Project	IEEE 802.16 Broadband Wireless Access Working Group < <a href="http://ieee802.org/16">http://ieee802.org/16</a> >
Title	Service Primitives for Paging Group Action
Date Submitted	2005-07-11
Source(s)	Jee Hyeon Na, <a href="mailto:jhna@etri.re.kr">jhna@etri.re.kr</a> Yun Won Chung, PhD <a href="mailto:yun.chung@etri.re.kr">yun.chung@etri.re.kr</a> Sang Ho Lee, PhD <a href="mailto:leesh@etri.re.kr">leesh@etri.re.kr</a> ETRI, 161, Gajeong-dong, Yuseong-gu, Daejeon, 305-700, Korea Voice: +82-42-860-5408 Fax: +82-42-861-1966
Re:	Call for Comment on P802.16g Baseline Document
Abstract	This contribution proposes service primitive for paging group action
Purpose	The document should be considered during the resolution of comments on the baseline document.
Notice	This document has been prepared to assist IEEE 802.16. It is offered as a basis for discussion and is not binding on the contributing individual(s) or organization(s). The material in this document is subject to change in form and content after further study. The contributor(s) reserve(s) the right to add, amend or withdraw material contained herein.

# Service Primitive for Paging Group Action

Fig. 2 - Paging Group Action Procedures

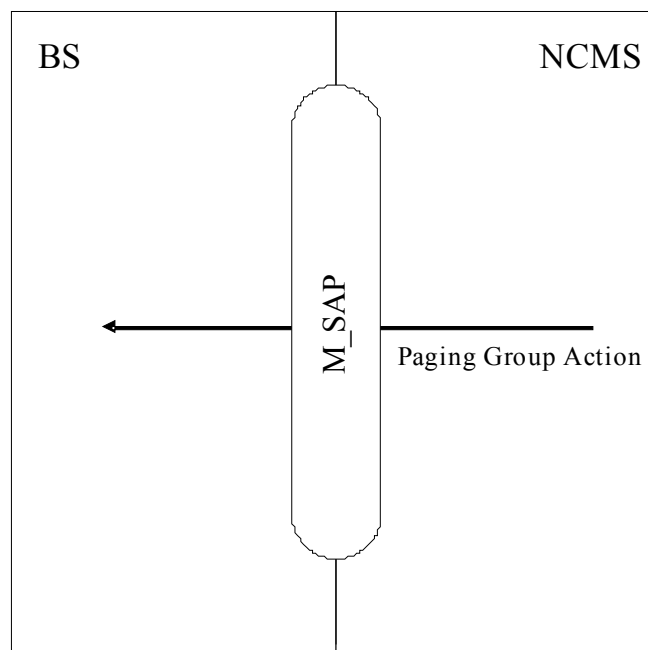
[Modify section 14.5.9.2 as follow]

The location information of an idle MSS is managed by the unit of Paging Group in Paging Service of an NCMS, and paging messages are sent to all the BSs within the called MSS's Paging Group. The NCMS should divide the whole service area into multiple Paging Groups and notify this Paging Group information to all the BSs within the service area, where a BS may be a member of one or more Paging Groups. In this contribution, we propose service primitives for Paging Group Action which are exchanged through Management Service Access Point (M-SAP) of Management Plane specified in IEEE 802.16g baseline document. Paging Group Action is performed by Paging Service of an NCMS, as shown in Fig. 2
